Volume III: Public Participation Report

Proposed Sheepmoor Wind Energy Facility and Associated Grid Infrastructure, near Ermelo, Mpumalanga

PREPARED FOR
14/12/16/3/3/2/2613
FINAL FOR DFFE DECISION

DATE
25 August 2025

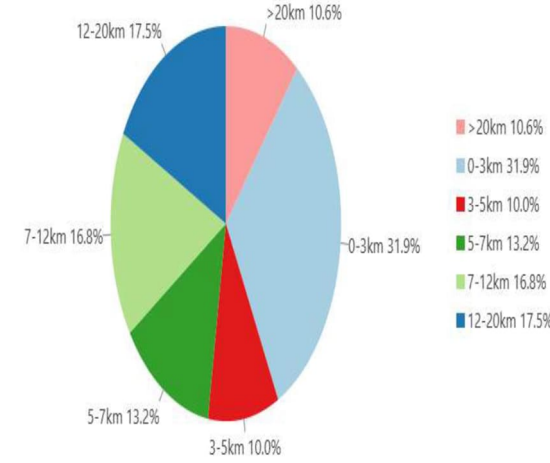
Species	Risk	RDL Status	African Grass Owl	High	Vulnerable	Cape Vulture	Medium	Endangered (Regionally)	Grey Crowned Crane	High	Endangered	Rudds Lark	High	Endangered	Secretarybird	Very High	Endangered (globally)	Southern Bald Ibis	Very High	Vulnerable	White-winged Flufftail	Very High	Critically Endangered	Wattled Crane	High	Critically Endangered	Yellow breasted Pipit	Very High	Vulnerable	Specialist Response: MTPA citing information from the draft Strategic Environmental Assessment (SEA) for Phase 3 for Wind and Solar Photovoltaic Energy (i.e., REDZ Phase 3) that currently remains under peer review and was shared in confidence by the CSIR on behalf of the DFFE with MTPA for comment constitutes a serious breach of ethical conduct and professional trust. As data information from the REDZ Phase 3 SEA has not been published yet and is currently being revised based on the updated red data statuses, the specialist is not in a position to respond to this comment.
Species	Risk	RDL Status																																	
African Grass Owl	High	Vulnerable																																	
Cape Vulture	Medium	Endangered (Regionally)																																	
Grey Crowned Crane	High	Endangered																																	
Rudds Lark	High	Endangered																																	
Secretarybird	Very High	Endangered (globally)																																	
Southern Bald Ibis	Very High	Vulnerable																																	
White-winged Flufftail	Very High	Critically Endangered																																	
Wattled Crane	High	Critically Endangered																																	
Yellow breasted Pipit	Very High	Vulnerable

No.	Name and Organization	Date and Method	Phase of PPP	Comment	Response
				 Figure 3: Spatial extent of the Tier 2 draft SEA REDZ 3 avian risk sensitivity layer covering Emvelo and Sheepmoor.	
				Buffers: Southern Bald Ibis The specialist proposes shaped buffers based on modelled flight patterns, allowing turbines effectively within 506m (potentially as close as 100m) of roosts/nests. This represents a significant reduction from standard recommendations (1-2.5km) and appears inadequately precautionary, especially as it doesn't explicitly incorporate rotor overhang. Concern is raised about the accuracy and reliance of flight paths derived from observational vantage points. Confidence in these buffers is further reduced by the extremely limited flight path data used in their modelling. In the absence of a validated or peer-reviewed model, the MTPA recommends a minimum 1km buffer around these breeding colonies, which would require removal of turbines 28, 29, and 41. See Figure 4 for the 1km buffer zone and affected turbine	Specialist Response: Noted. The delineation of the turbine exclusion (sensitivity) zones for Southern Bald Ibis (SBI) was based on a continuous flight risk surface derived from flight data and spatial modelling of flight behaviour around known roost and colony sites. To define the risk categories (High and Medium), we applied an empirical thresholding approach informed by observed flight density patterns. Specifically, the High-Risk zone was delineated to encompass the core 70% of modelled flight activity, with a target of including at least 70% of all recorded SBI flight points surrounding known roosts and colonies. The final High-Risk Zone achieved coverage of approximately 75% of all observed flights, slightly exceeding the target to ensure conservative spatial buffering around high-use areas. The Medium Risk zone was extended outward to capture a broader range of movements, aiming to encompass over 80% of recorded SBI flights. The final modelled zone covered approximately 79% of

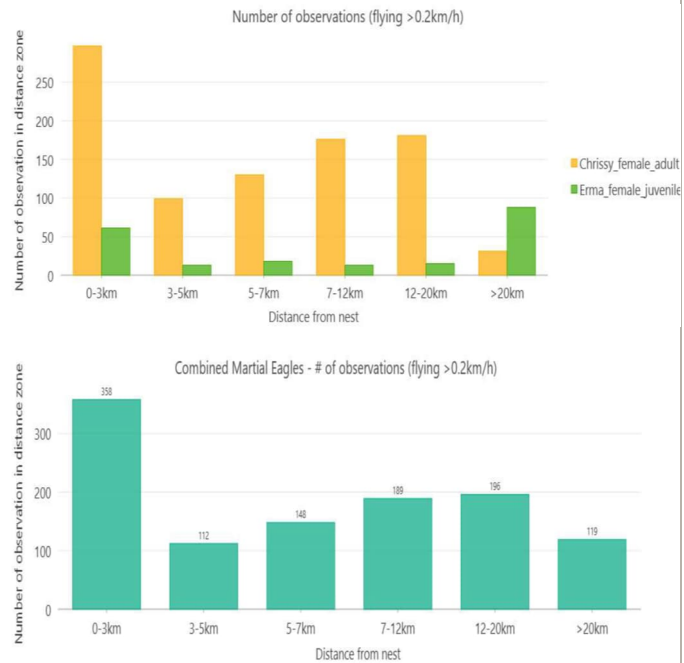
No.	Name and Organization	Date and Method	Phase of PPP	Comment	Response
				placement of turbines 17 (Emvelo) and 18 (Sheepmoor). These localities are buffered and mapped in Figure 5.  Figure 5: African Grass Owl (Vulnerable) localities with the recommended 1160 m buffer to cover their strict home range of 423 ha.	
				Buffers: Martial Eagle The MTPA has significant concerns regarding the use and modelling of Martial Eagle collar data. The MTPA obtained a copy of the flight data containing 13,111 observation points, compared to the 13,680 observations used by AfriAvian. We used GIS to confirm key findings in the avifaunal assessment, focusing only on data from juvenile and adult tracking collars around the Emvelo and Sheepmoor sites, excluding the Free State male. EWT previously advised using a 5-6 km buffer around nest sites. More recently, BirdLife (2025) recommended a 6 km	Specialist Response: Noted. The flight risk model and sensitivity zonation for Martial Eagle were developed using a combination of tracking data, focused field observations, and high-resolution environmental predictor variables. While the model incorporates GPS data from one adult (13 months, 6380 transmitted locations) and one juvenile individual (5 months, ~1450 transmitted locations) at the project site, it also includes tracking data (12 months, ~5850 transmitted locations) from a second adult male Martial Eagle monitored at a comparable highland grassland site. This second dataset extended to approximately 12 months and exhibited a remarkably similar spatial use pattern. Together, these datasets provided a robust basis for

No.	Name and Organization	Date and Method	Phase of PPP	Comment	Response
				buffer around nesting sites. This recommendation aligns with preliminary outputs from the National Martial Eagle Risk Assessment (MERA) tool led by the University of Cape Town, which supports applying a circular buffer of approximately 5 km to include core ranges heavily utilised by resident breeding Martial Eagles, rather than applying bespoke buffers based on tracking and observational flight path data. Given 40 individual collared Martial Eagle tracking datasets, researchers could not build a reliable model to guide wind farm development, as Martial Eagles appear particularly difficult to model for flight patterns. Against this backdrop, it is concerning that AfriAvian claimed they could accurately model flight risk for Martial Eagles and were confident enough to reduce the nationally recommended buffer by more than 50% (to 2.5 km for the High Risk zone). Such confidence in model output would be required to make this bold decision, as any failure may result in the loss of both parents and the entire breeding pair.	assessing spatial flight activity in relation to nest proximity and landscape features. In addition to the tracking data, over 37 hours of direct Martial Eagle flight observations were recorded near the nest site during 60 hours of targeted pre-construction surveys. This effort produced a substantial dataset of localized flight behavior, which was used to train a flight risk model (FRM) using an artificial neural network (ANN). The ANN was developed using a suite of predictor variables representing topography (e.g., slope, ruggedness, TWI), hydrology, and remotely sensed vegetation productivity indices. This enabled a data-driven approach to modelling spatial risk beyond traditional buffer methods. Regarding the delineation of high and medium sensitivity zones: the original high-risk zone (~80 km²) closely mirrors the area of a 5 km circular buffer recommended by BirdLife South Africa and EWT. However, based on the tracking and observation data showing that ~75% of recorded activity occurred within 3 km of the nest, a more precautionary Very High Risk zone (~31 km²) was delineated, within which no wind turbines will be permitted. The Medium Risk zone (~148 km²) now incorporates a more stringent mitigation regime than conventional practice, including both automated Shutdown-on-Demand (SDOD) and dynamic diurnal curtailment during periods of expected eagle activity.

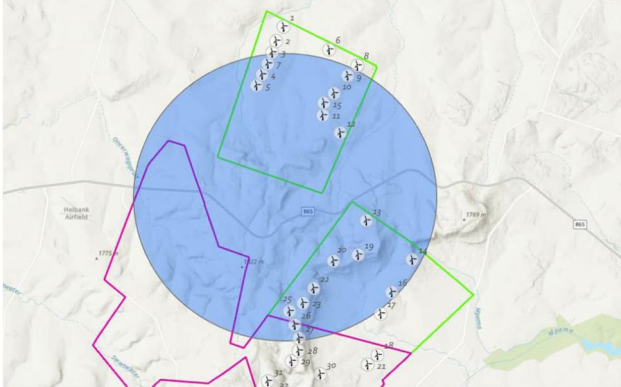
Statistical Flaws in the Model: The flight risk model created using machine learning combined coarse-scaled GPS data across a wide area with fine-scaled, dense flight path data from a very limited area (majority within 2 km of nest) (see Figure 18 in the avifaunal assessment). Incorporating detailed, fine-scaled observational flight paths from such a limited area introduces spatial bias, where model output is disproportionately influenced by the more detailed sampling from the fine-resolution area, leading to overrepresentation of that smaller region. This approach is statistically flawed when differences in spatial area, resolution, sampling intensity, and density are not properly accounted for. This violates spatial statistical assumptions, resulting in inconsistent variance estimates, inaccurate predictions, and biased interpretations that do not accurately reflect broader spatial patterns.

No.	Name and Organization	Date and Method	Phase of PPP	Comment	Response
				km ²) recommended by BirdLife and EWT. However, AfriAvian then extracted from the High risk zone a "Very High risk zone" as their no-go area, relying on Martial Eagle tracking and in-field observational data showing approximately 75% of recorded flight activity within 3 km of the nest. This was not only a subjective decision lacking scientific rigour, but as demonstrated below, the approach is fatally flawed	rather to reflect biologically informed risk thresholds derived from empirical data. The risk model thresholds themselves remained unchanged; what changed was the delineation of more conservative spatial zones to better reflect the observed space use and mitigate risk more effectively. While we acknowledge the limitations inherent in working with a small sample size — which is a known challenge for this species — the modelling approach integrates multiple lines of evidence and has prioritized precaution in delineating turbine exclusion zones and mitigation areas. The intent is to implement a risk-responsive mitigation hierarchy that reduces potential collisions. Due to the limitations of the GPS data — specifically, inconsistent one-hour ping intervals — we chose to analyze bird movement using proportion of time spent within distance bands rather than flight paths or number of GPS points – see Figure 1 below. This approach better reflects where birds are likely to face greater risk, as time spent in a zone is a more reliable metric given the data resolution. Our chart represents delta time across zones, not distance travelled or observation count, and we believe this method is the most appropriate and transparent given the data quality. Figure 1: Proportion of time spent by the tracked Martial Eagles (ME) within varied distance bands from the nest site (April 2024 to May 2025).

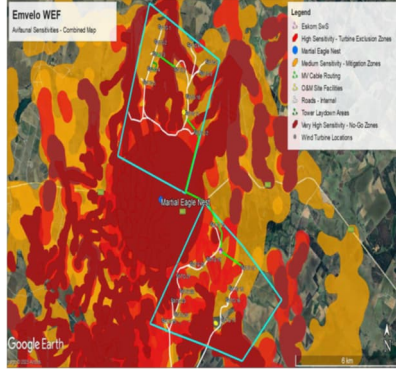
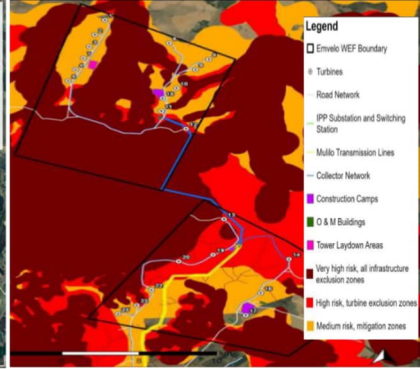
3.13. Concern was raised about WTG 15 being located in a Key Biodiversity Area (KBA) that is untransformed (page 15 Emvelo CRR). In reply the EAP states that WTG 15 was removed from the final layout. This is not the case! Examination of the extract from Figure 6 – Important Ecological Areas (from the figures volume attached to the July 2025 Draft EIA Report) shows that both WTG3 and WTG 15 remain located in a CBA (green shading), albeit in a different position relative to the March 2025 Draft EIA Report. A construction camp is located next to the WTG and is also shown situated in a CBA. What is the explanation for this? Therefore, the relocation of WTG 15 does not seem to have offered any advantage from an avoidance of an adverse impact on biodiversity perspective. The lower image is extracted from the Biodiversity Offsets Report and it can be seen that both WTG 3
